Public Comment Received for:

Item 5: 1460 La Cima Rd

(PLN2019-00279)

March 11, 2022

1460 La Cima Road – Comments to Sheet A 5.0

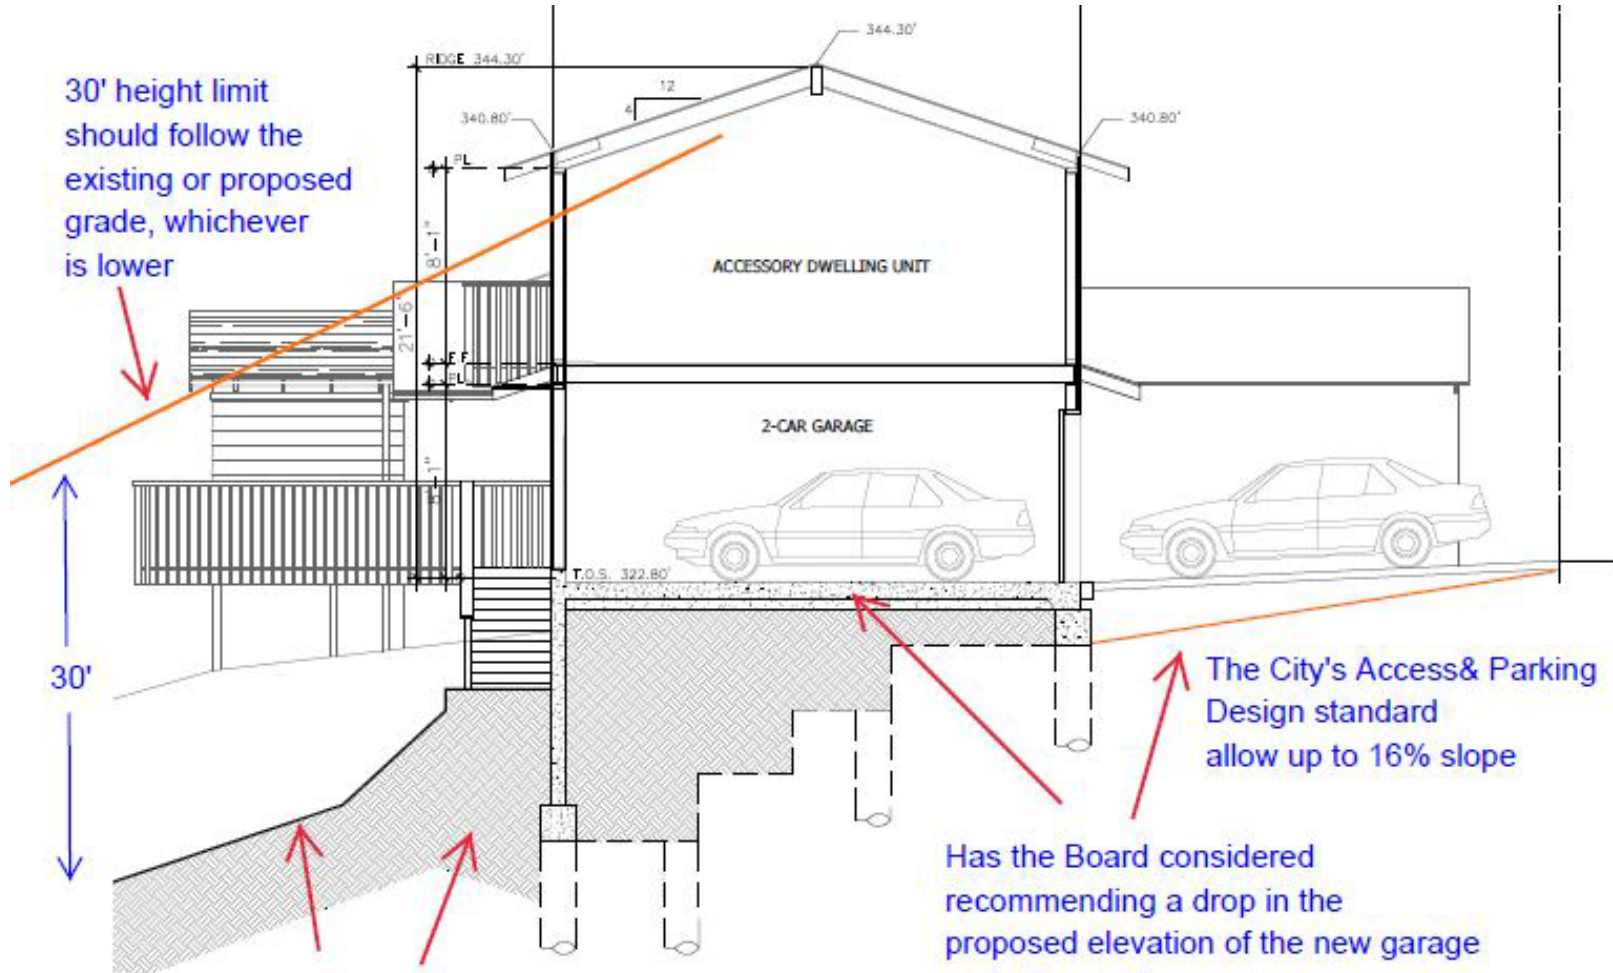
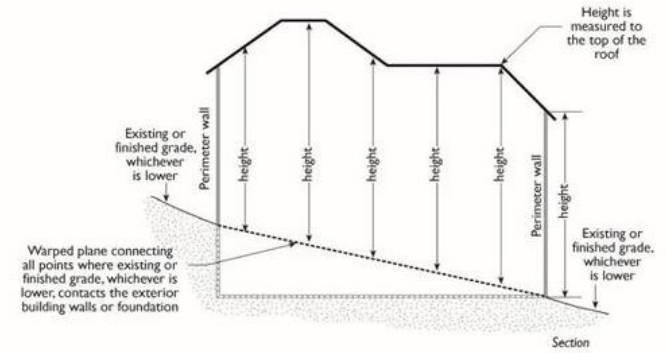
Sheet A 5.0: The same comments pertaining to height on Sheet 4.2 above, apply to Sheet 5.0. Also has the Board considered a drop the elevation of the proposed garage and the driveway? The City's Access and Parking Design Standards state the maximum slope for a driveway is 16%.

Show elevations of existing grade, natural grade (if different) and proposed grade. Show height measured from natural or proposed grade, whichever is lower
